Access Compliance Report

Public Rights-of-Way

(Curb Ramps)

Intersection ID: 49297	Main Street: CAMPBELL_HALL_CT	Cross Street: CHAMBERLIN_RD	Location: NE
ADA ID: E0DEA0AD3530	Ramp Type: Perp	Initial Pass/Fail: Fail	Overall Compliance: No
Severity Score: 1.25			
Codes/Mitigation Info/Possible Solution		Field Measurements/Component Compliance

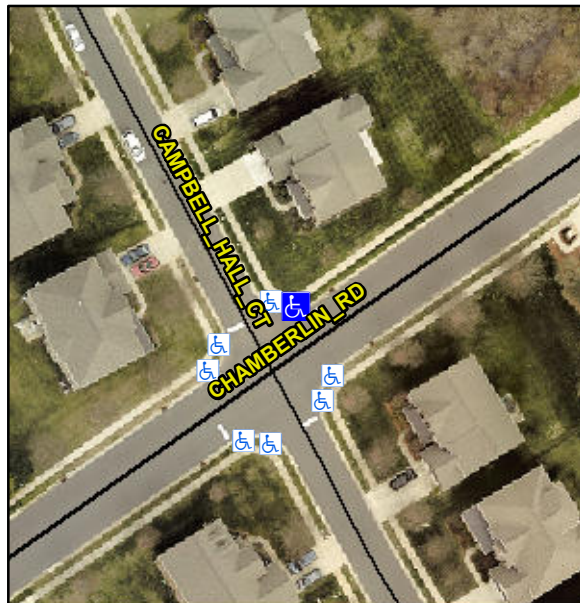
Not Found, R304.5.3

Compliance	Description	Data	Compliance	Description	Data
N/A	Ramp Length (in)	49.0	Yes	Ramp Slope (%)	8.2
Yes	Ramp Width (in)	48.0	No	Ramp XSlope (%)	2.4
N/A	Flare Type LT	N/A	N/A	Flare Type RT	N/A
N/A	Flare Slope LT (%)	N/A	N/A	Flare Slope RT (%)	N/A
N/A	Flare Traversable LT?	N/A	N/A	Flare Traversable RT?	N/A
N/A	Landing Length (in)	N/A	N/A	DWS Provided?	N/A
N/A	Landing Width (in)	N/A	N/A	DWS Contrast?	N/A
N/A	Landing Slope (%)	N/A	N/A	DWS Length (in)	N/A
N/A	Landing X Slope (%)	N/A	N/A	DWS Full Width?	N/A
N/A	Landing Curb? (Y/N)	N/A	N/A	DWS Offset (in)	N/A
N/A	Shared Landing?	N/A			
N/A	Gutter Ponding?	N/A	N/A	Gutter Slope (%)	N/A
N/A	Gutter Lip Ht (in)	N/A	N/A	Gutter X Slope (%)	N/A
N/A	Painted X Walk1?	No	N/A	Painted X Walk2?	N/A
	X Walk 1 Direction	To SE		X Walk 2 Direction	N/A
N/A	X Walk 1 Width (in)	N/A	N/A	X Walk 2 Width (in)	N/A
	X Walk 1 Slope (%)	2.7		X Walk 2 Slope (%)	N/A
	X Walk 1 X Slope (%)	0.1		X Walk 2 X Slope (%)	N/A

N/A	Ramp inside XWalk1?	N/A	N/A	Ramp inside XWalk2?	N/A
	Road Slope (%)	N/A	N/A	Clear Space?	N/A
	Road X Slope (%)	N/A	N/A	Clear Space to XWalk (in)	N/A
N/A	Any Obstructions?	N/A	N/A	Storm Grate/Utility Hazard?	N/A
	Obstruction Type			Storm Grate/Utility Type	
		N/A			N/A
		Yes		Surface Condition? (G/P)	Good

Remove & Replace Entire Ramp.
